SUBJECT: NuScale Power, LLC Submittal of the Approved Version of NuScale Topical Report TR-0116-21012, "NuScale Power Critical Heat Flux Correlations," Revision 1

NuScale Topical Report, TR-0116-21012-P-A, "NuScale Power Critical Heat Flux Correlations," Revision 1, proprietary version

SUBJECT: FINAL SAFETY EVALUATION FOR NUSCALE POWER, LLC TOPICAL REPORT-
0116-21012, REVISION 1, "NUSCALE POWER CRITICAL HEAT FLUX
CORRELATIONS"

Figure 1. []

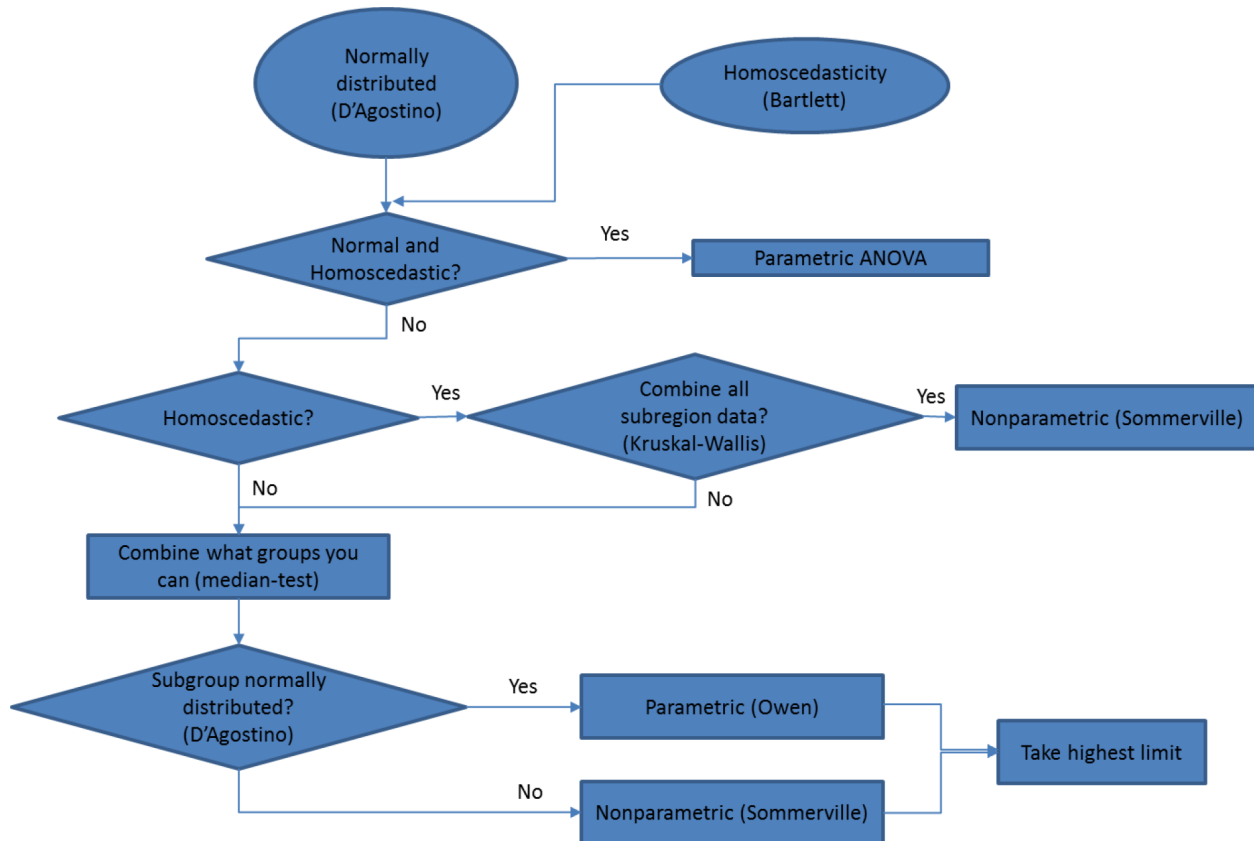
Section 3.3.2.1 of this SE explains the process of splitting up the validation data. The NRC staff further investigated this process during an audit, where it observed that the NuScale process for

developing the CHFR limit involved several statistical tests to determine (1) whether subregions can be combined (i.e., pooled), and (2) whether the data can be treated as normally distributed. The NRC staff developed a flow chart, provided in Figure 1, to clarify the NuScale process for developing the CHFR limit. The statistical tests used by NuScale, and shown in Figure 1, are consistent with those described in NUREG-1475, Revision 1, “Applying Statistics” (Reference 24). Based on the description of these methods in NUREG-1475, the NRC staff finds that these statistical tests are consistent with established practice and are therefore acceptable. Additionally, based on NuScale [], the NRC staff finds the process used to select the CHFR limit acceptable.
